ADDENDUM NO. 1

To all prospective bidders on the Work titled: **Robles Canal Road Paving and Concrete Panel Replacement (Specification No. 26-481)**

The Drawings and Project Manual including Specifications are modified as follows. This Addendum forms a part of the Contract Documents and modifies the original documents dated July 24, 2026.

REDWOOD HEADER

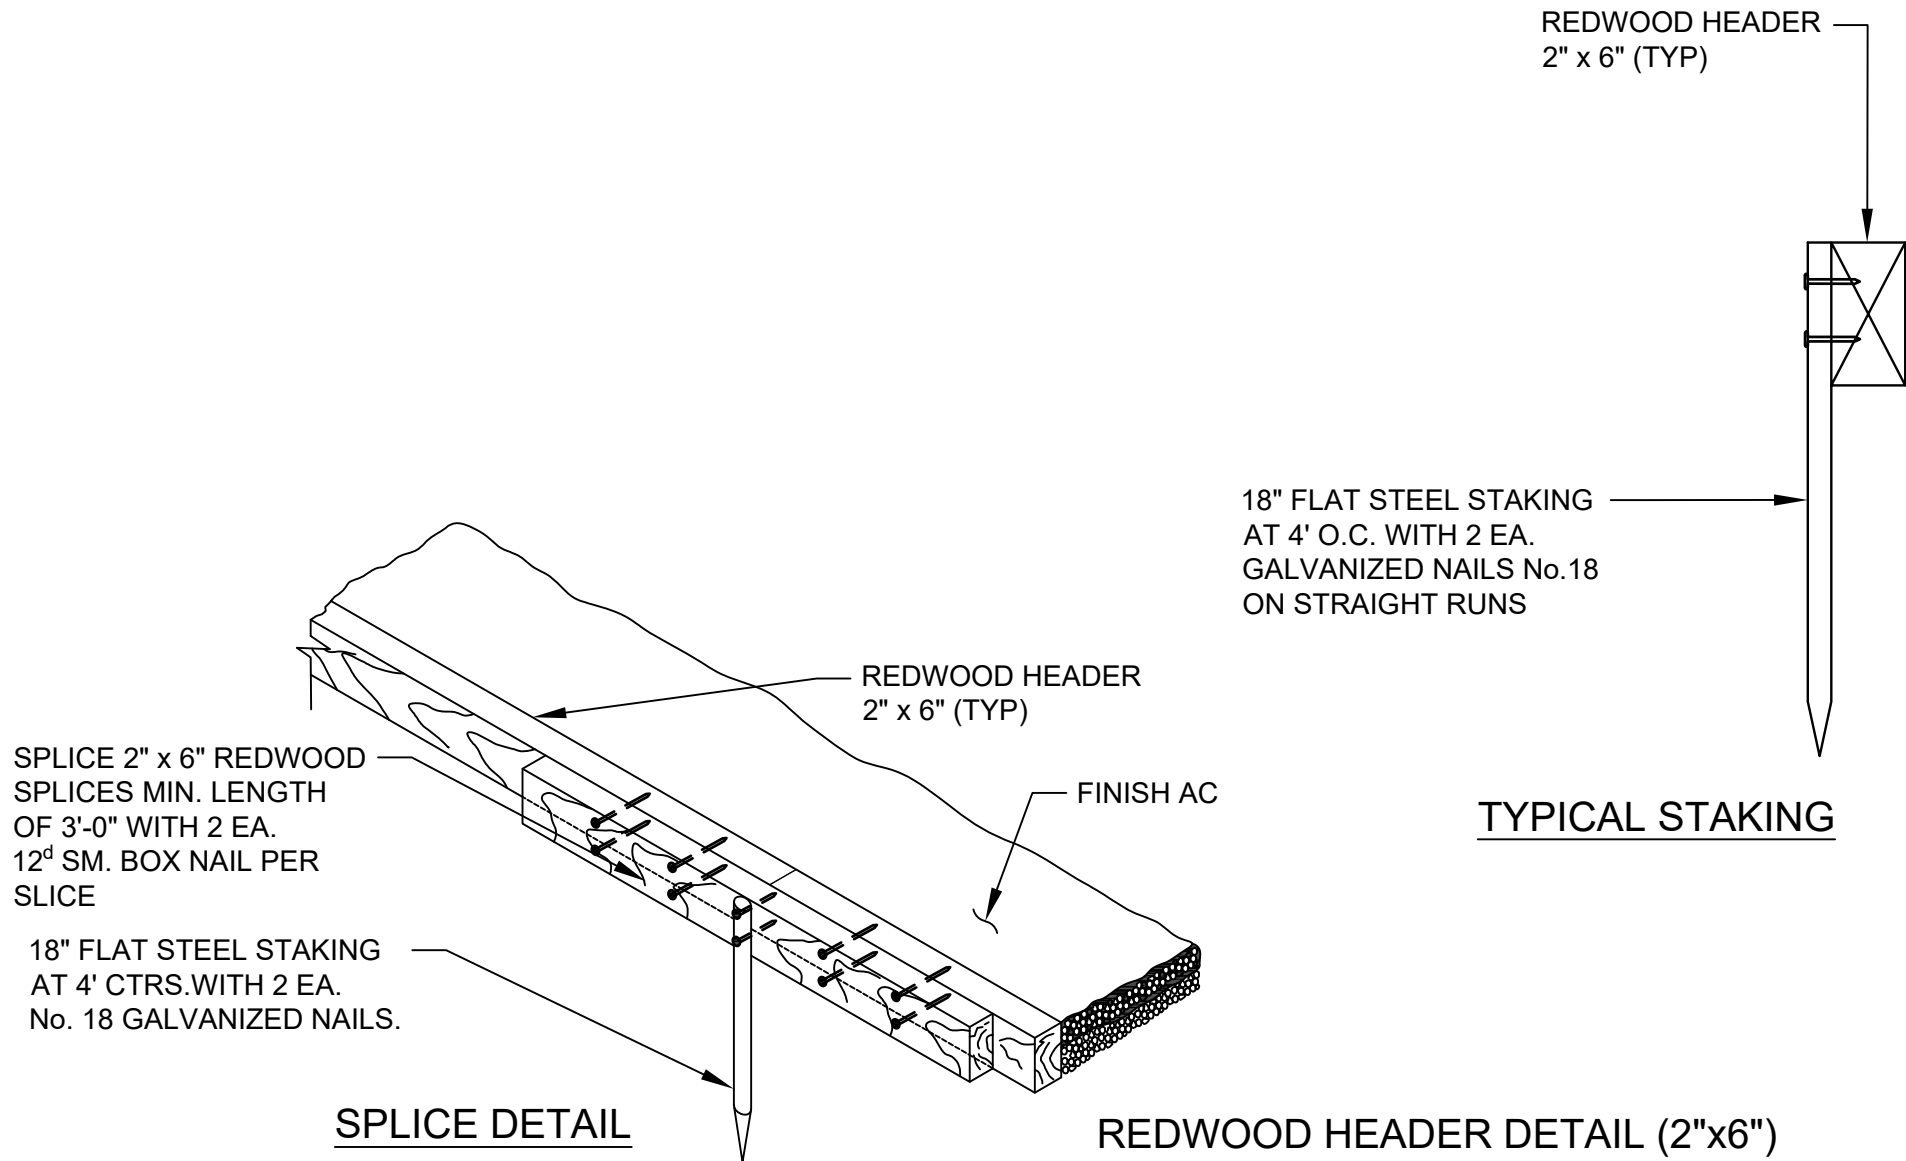
Item AD1-7 Appendix B ADD Redwood Header Detail (attached).

This work shall include the unit price to install 4,150 linear feet of 2” x 6” redwood headers with 18-inch flat steel stakes at 4 feet on center adjacent to asphalt concrete pavement replacement work.
